ADDENDUM NO. 1

This addendum includes Item Number 1-1 thru 1-76. This addendum item shall be fully incorporated into the Bidding/Contract Documents and have the same force and effect as though originally included.

Life Sciences Collaboration
1910 N. Antelope Valley Parkway
Lincoln, Nebraska
TCEP No.: 716-002-12
Davis Design.: 12-0077
BVH No.: L12018.unl
November 27, 2013

Item 1-71: Sheet E1.31 – Third Floor Lighting Plan – Area ‘A’

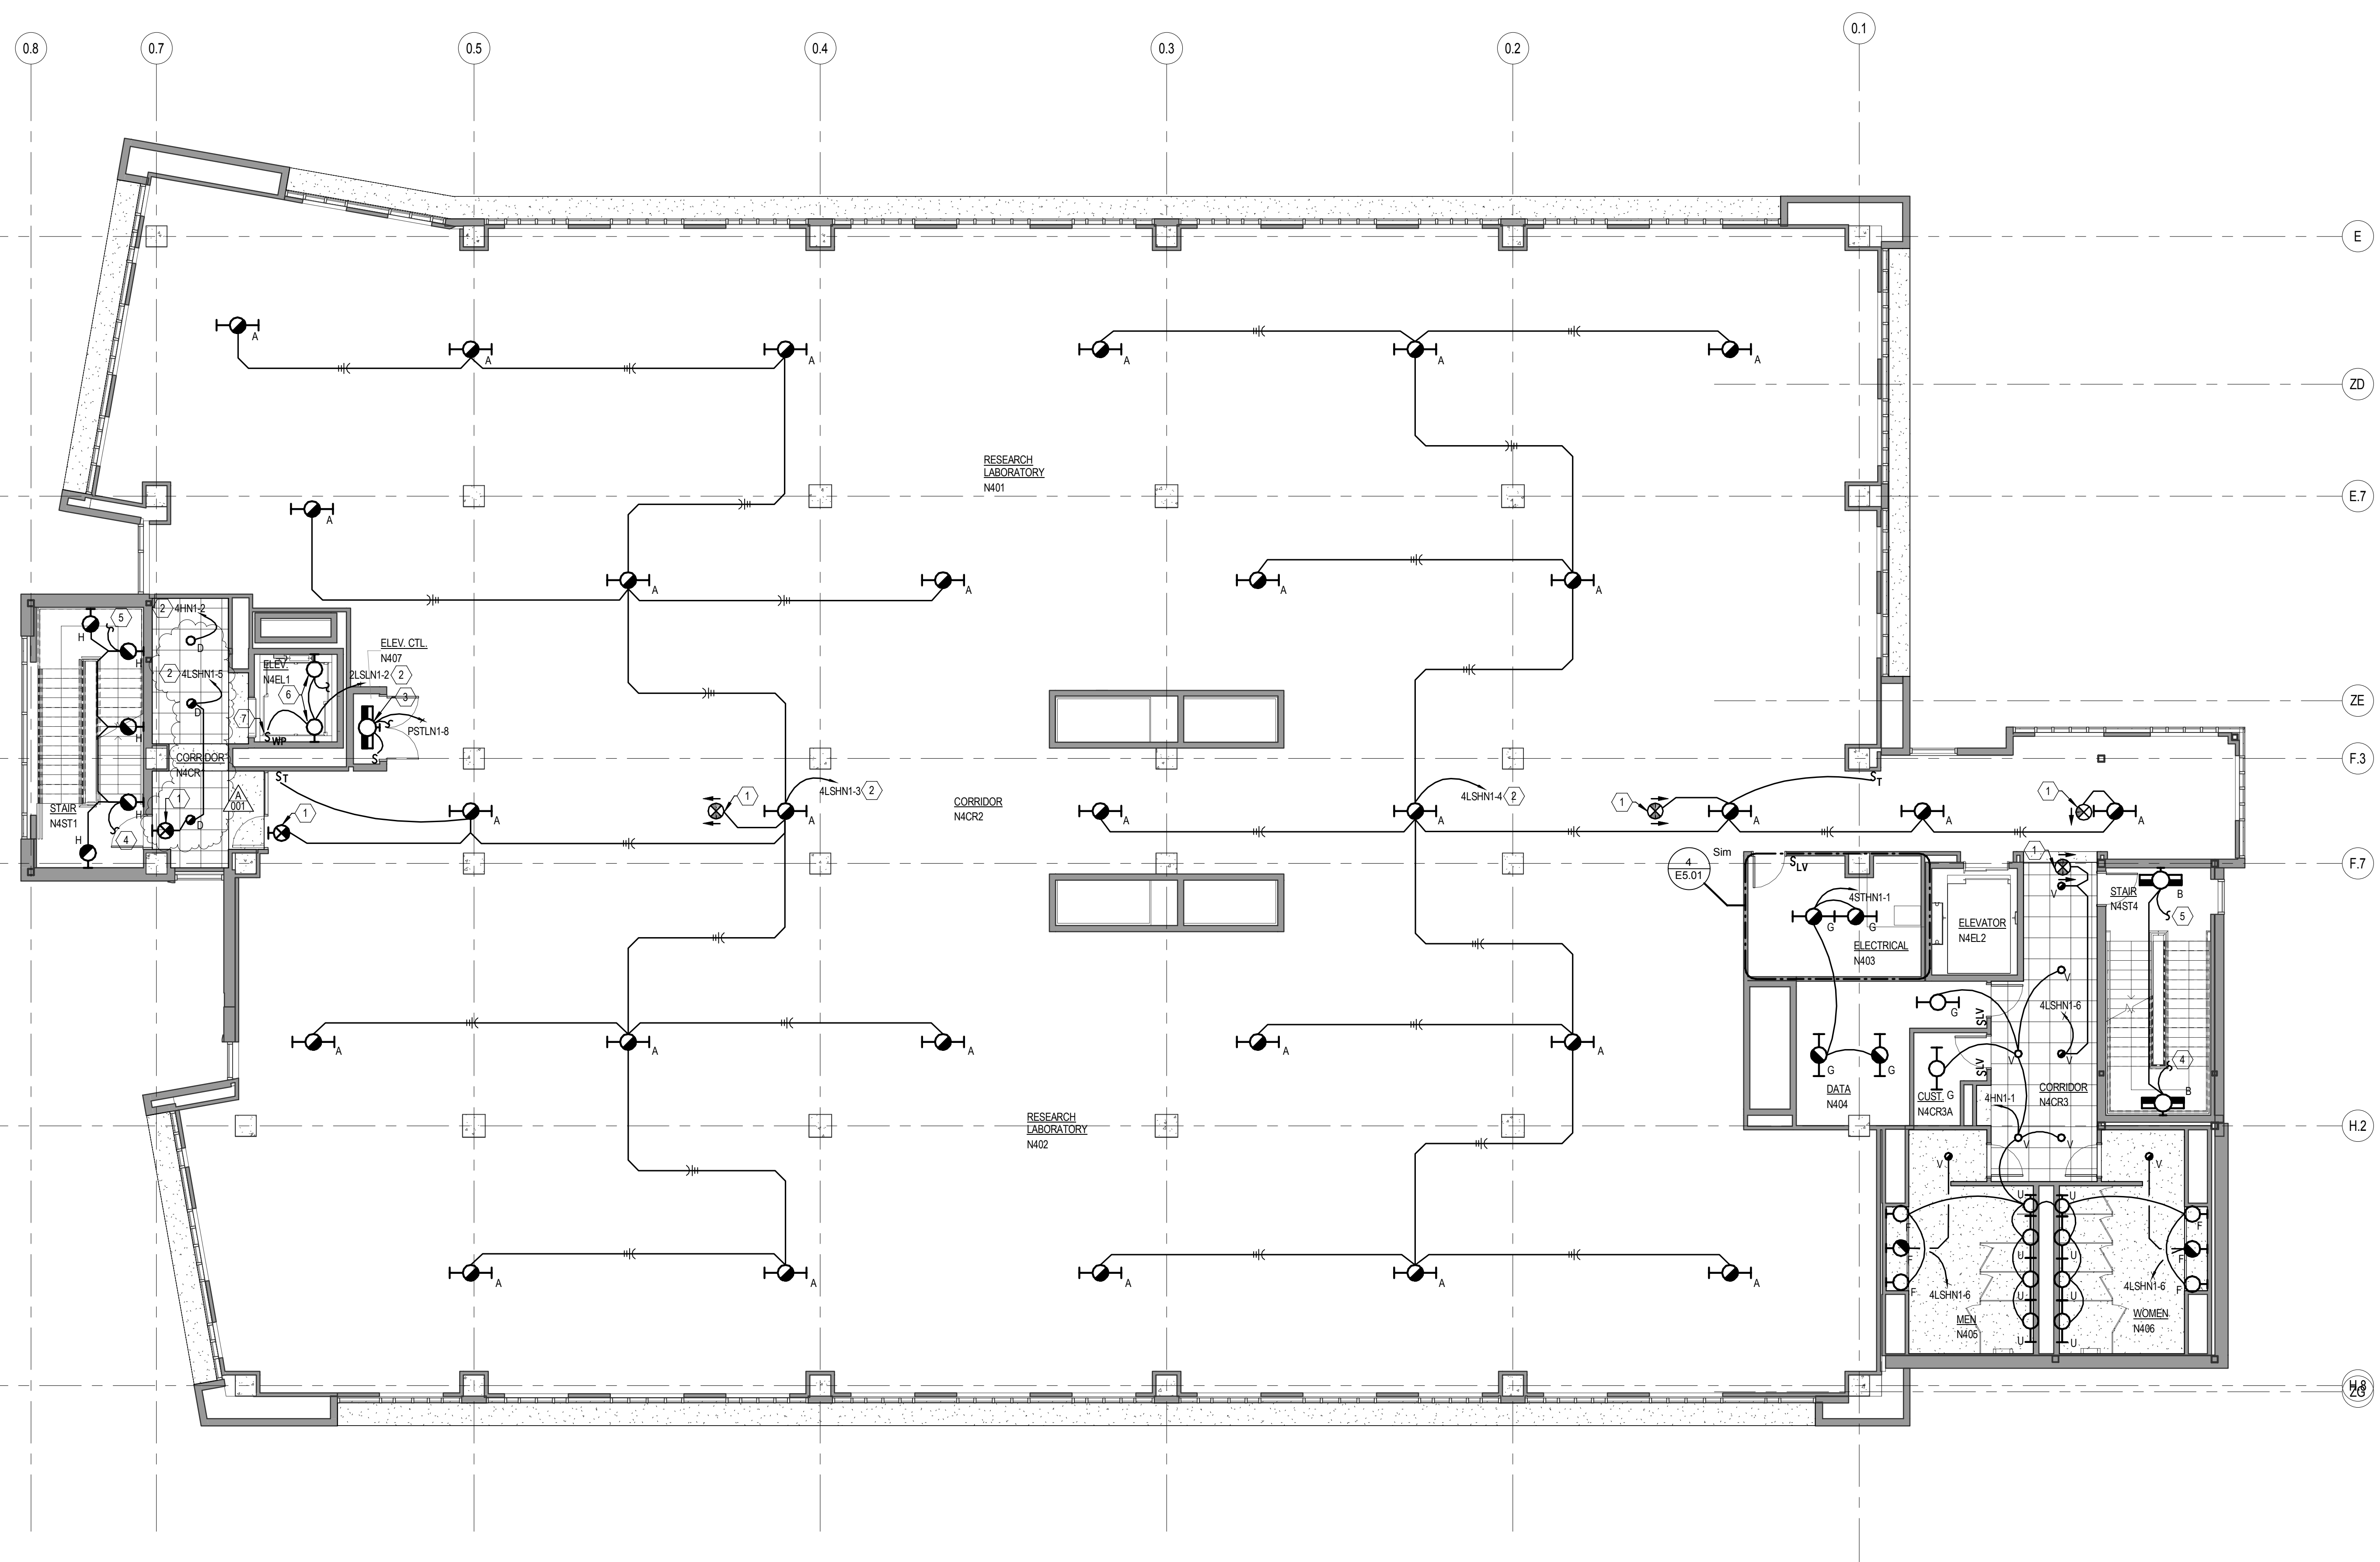
Switch Type ‘V’ fixture to Type ‘D’ fixture in Corridor N3CR1 and adjust layout. See re-issued sheet E1.31 for changes.
